THE PRESERVE AT SAN JUAN

Final Environmental Impact Report – EIR No. 618

December 2017

The Preserve at San Juan
Figure 3-1
 Cumulative Projects

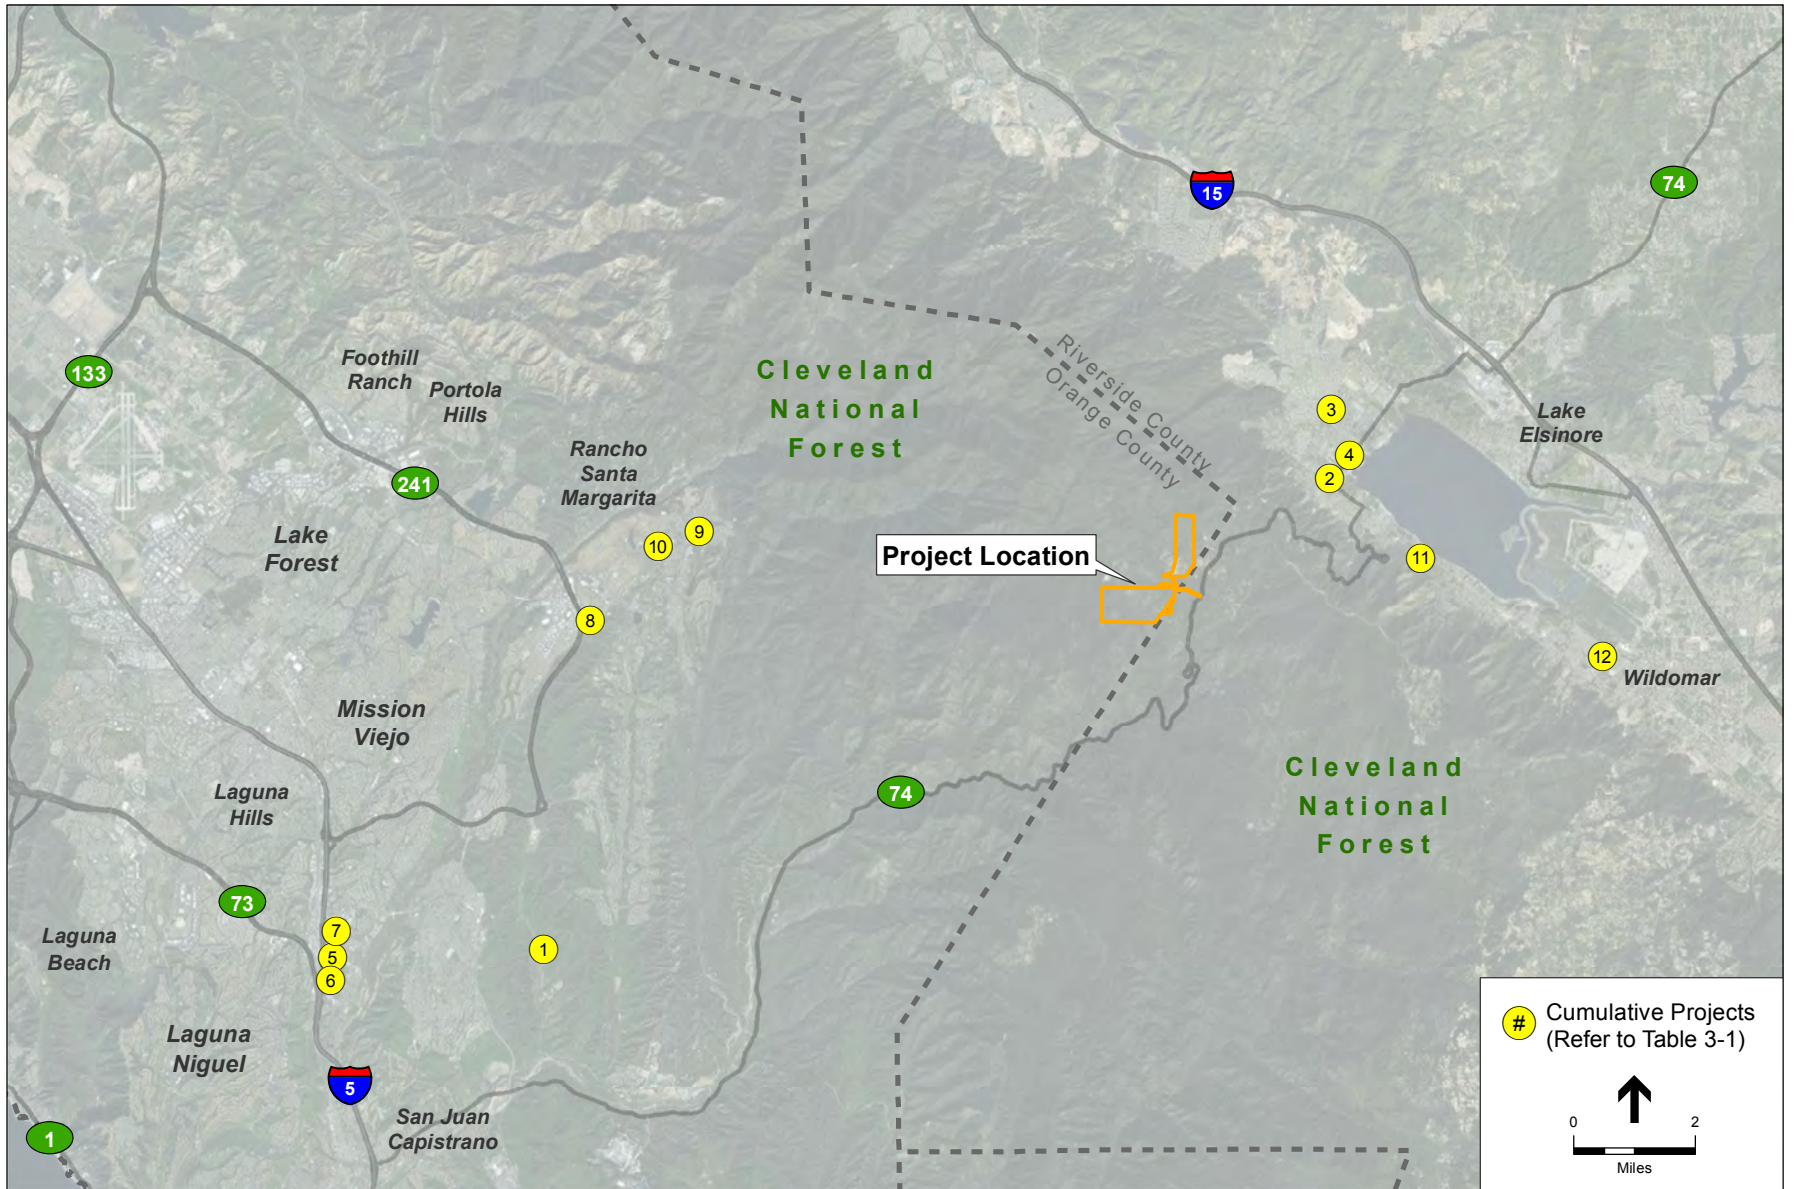
Pages 3-6 and 6-8: Table 3-1, Cumulative Projects List and the numbering of cumulative project locations in Figure 3-1 is hereby revised as follows:
